# UNITED STATES PATENT AND TRADEMARK OFFICE

APPLICATION NO.	FILING DATE	FIRST NAMED INVENTOR	ATTORNEY DOCKET NO.	CONFIRMATION NO.
10/806,414	03/23/2004	Kimiaki Ando	1743/232	2294

# Office Action Summary

***Detailed Action***

**Fig.1 (Prior Art)**

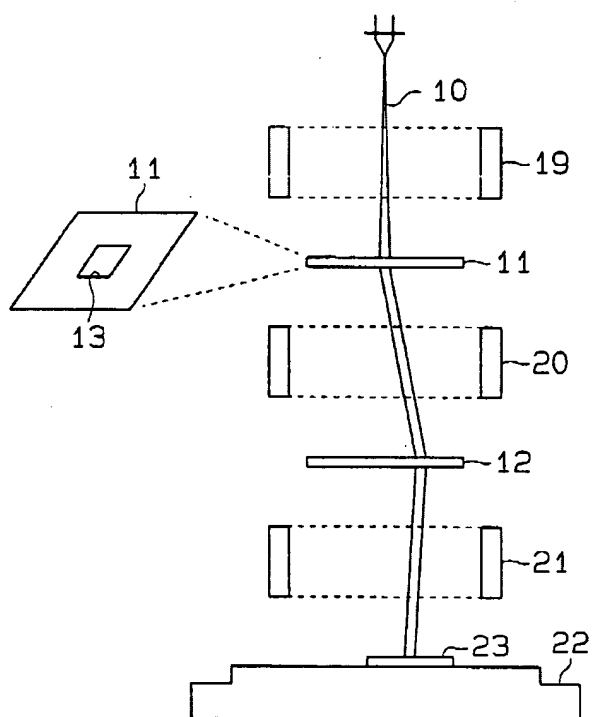
Regarding claims 1,5, and 7, Miyajima (604) discloses the following;

An electron beam (EB) exposure apparatus in Fig. 1, having a stencil mask (or block mask) 12 and a plate 11 having a rectangular opening 13. As shown in FIG. 2, the stencil mask 12 has a plurality of first transmission apertures 14 having rectangular

shapes, and a plurality of block areas 15 (including a parallelogrammatic aperture). An electron beam 10 is deflected by a first electromagnetic deflector 19 before passing the plate 11. The electron beam 10 is then deflected by a second electromagnetic deflector 20 before passing any one of the first to third transmission apertures 14-17 of the stencil mask 12. Accordingly, the cross-sectional shape of the electron beam 10 or the shape of its exposure pattern is changed. The electron beam 10 after it has passed the stencil mask 12, is further deflected by a third electromagnetic deflector 21. As a platform or stage 22 is moved along the X and Y axes, a desired pattern is exposed on a predetermined area of a wafer 23 located on the stage 22.

The size of a rectangular pattern exposed on the wafer 23 is determined by adjusting the degree of overlapping of the beam passing through the plate 11 with the associated first transmission aperture 14. See Column 1, lines 10-15, and 31-46; also Figures 1 and 2 below;

**Fig. 13C****Fig. 13D**

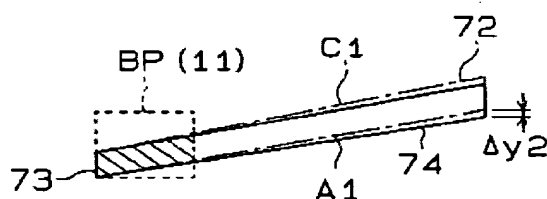
Regarding claim 3, Miyajima (604) discloses that, the CPU 32 selects a segmental block pattern, which approximates the modified second pattern 72. In this case, the CPU 32 selects a segmental block pattern BP(11) with a number "11" in FIG. 10 (indicated by the broken line in FIG. 13C).

The CPU 32 then enlarges the segmental block pattern BP(11) to generate an enlarged pattern 74. At this time, the length of the left side and the side D of the enlarged pattern 74 substantially coincide with each other. The CPU 32 acquires, as a difference value, a difference ( $\Delta y_2$ ) between the side A1 (or the side C1) of the

enlarged pattern 74 and the side A of the second pattern 72 in the direction of the Y axis. When determining that the difference value  $\Delta y_2$  is within the error allowance value range, the CPU 32 modifies the second pattern 72 to the segmental block pattern BP(11). That is, the CPU 32 stores the number "11" of the selected segmental block pattern BP(11) in a data area 75a, information indicative of "segmentation", a block type, in a data area 75b, and information indicative of "parallelogram", a pattern shape, in a data area 75c as shown in FIG. 14. Further, the CPU 32 stores the X coordinate and Y coordinate at which the second pattern should be laid out, in data areas 75d and 75e, and pattern size information in a data area 75f. As shown in FIG. 13D, exposure is carried out using the segmental block pattern BP(11) instead of the second pattern 72. See Column 11, line 57-67; and Column 12, line 1-15; and Figure 13D below.

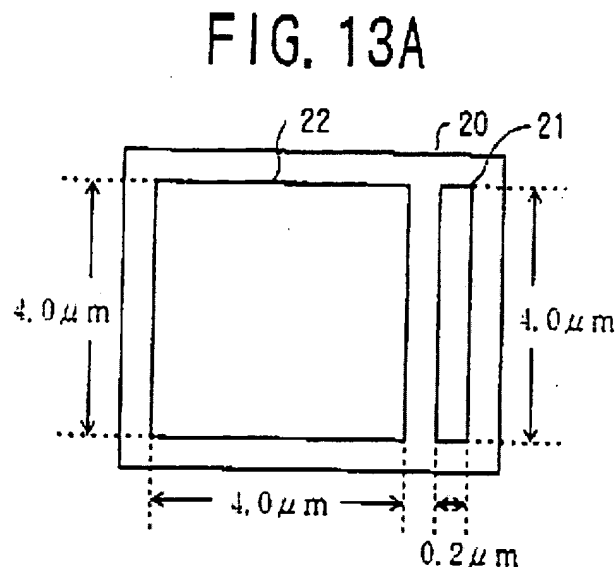
Miyajima (604) as applied above fails to teach the use of an aperture width of  $1\mu\text{m}$  or less. However, Sakakibara (155) discloses in n a block 20 of FIG. 13A, an

aperture 21 has a width of  $0.2\ \mu\text{m}$  and a length of  $4.0\ \mu\text{m}$ , and an aperture 22 is a  $4.0\ \mu\text{m}$  square. See Column 13, line 41-46; and Figure 13A below.

Therefore it would have been obvious to one of ordinary skill in the art that the exposure apparatus and method of Miyajima (604) can be modified to use an aperture width less than  $1\ \mu\text{m}$  in accordance with Sakakibara (155), to provide a mask having micro apertures, which makes it possible to limit the current amount of the electron beam passing through the apertures.
